Project	IEEE 802.16 Broadband Wireless Access Working Group <http://ieee802.org/16>	
Title	Frame Structure for Transparent Relay Mode	
Date Submitted	2007-01-16	
Source(s)	Gang Shen, Kaibin Zhang, Xiaobin Leng, Jimin Liu, Shan Jin Alcatel-Lucent, Research & Innovation 388#, Ningqiao Road, Shanghai, China.	Voice: 86-21-50551240-8194 Fax: 86-21-50554554 Email: gang.a.shen@alcatel-sbell.com.cn
	Torsten Fahldieck, Joerg Schaepperle, Roland Muenzner Alcatel-Lucent, Research & Innovation Lorenzstr. 10, D-70435 Stuttgart, Germany	Voice: 49-711-82132163 Email: torsten.fahldieck@alcatel.de
	Fang-Ching Ren, I-Kang Fu, Chie Ming Chou Industrial Technology Research Institute (ITRI) EE Building 2 R442 No.1, Sec. 4, Roosevelt Road, Taipei, Taiwan 106, China.	Voice : 886-3-5914786 Fax: 886-3-5820371 Email: frank_ren@itri.org.tw
	Michiharu Nakamura, Fujitsu Laboratories Ltd. 5-5 Hikarino-oka, Yokosuka-shi, Kanagawa-ken, 239-0847 Japan	Voice : 81-468-39-5371 Fax : 81-468-39-5560 Email: michi@labs.fujitsu.com

Frame Structure for Transparent Relay Mode

Figure xxx Example of minimum configuration for an in-band transparent relay frame structure

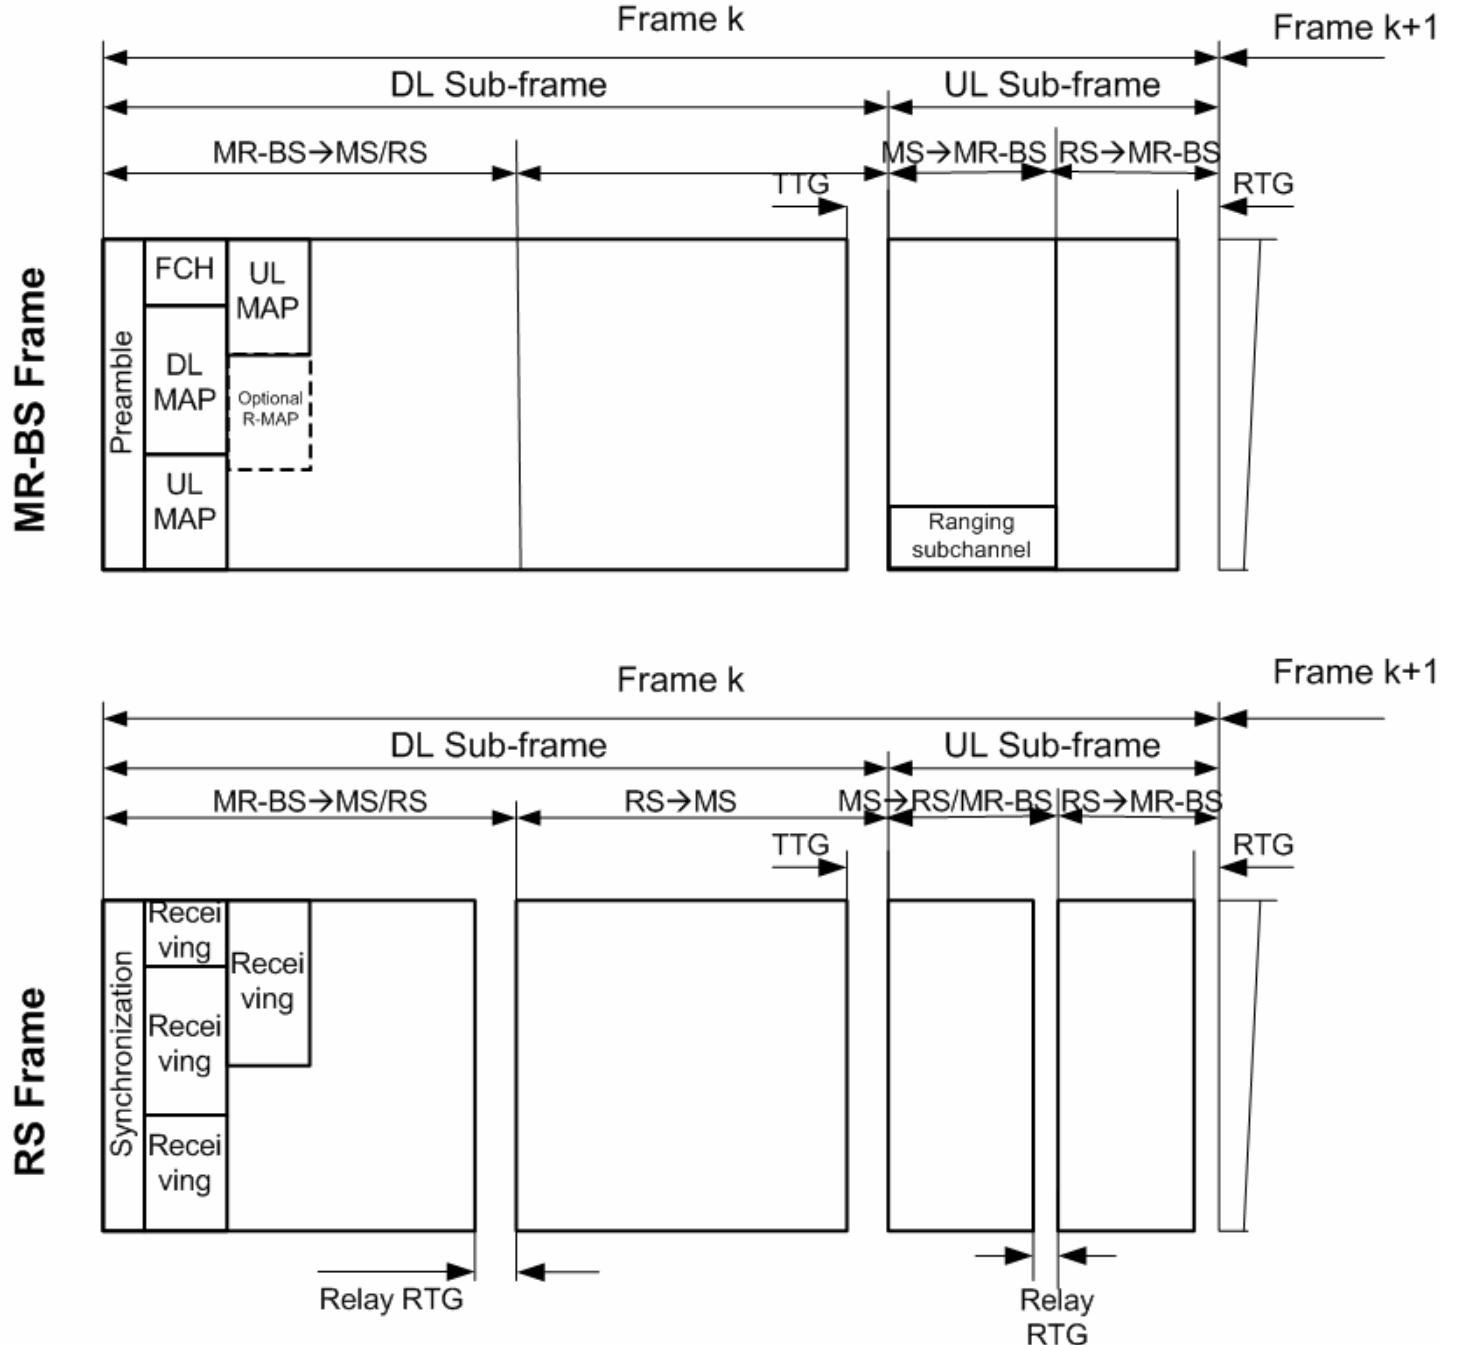
[For the TDD mode, an example of the MR-BS frame structure is shown in Figure xxx.](#)

Each frame in the downlink transmission begins with a preamble followed by an FCH, DL-MAP, and possibly UL-MAP. R-MAP is located following legacy MAP or defined as an extension of legacy MAP. The frame structure consists of DL sub-frame period and UL sub-frame period. In each frame, the TTG shall be inserted between the DL sub-frame and the UL sub-frame. The RTG shall be inserted at the end of each frame. One common ranging subchannel is shared by all RSs and MSs within one MR-cell.

The DL sub-frame shall include at least one zone for MR-BS to its subordinate MR/RS transmissions and may optionally include a transparent access zone / region for RS to MS transmissions. The transparent access zone can be indicated by STC_DL_ZONE IE() defined in Table 279. The UL sub-frame may include a zone for MS to MR-BS / RS transmissions and optionally include a zone for RS to MR-BS transmissions. The bandwidth allocation for transmissions between MR-BS and MS / RS follows legacy IEEE802.16e operation.
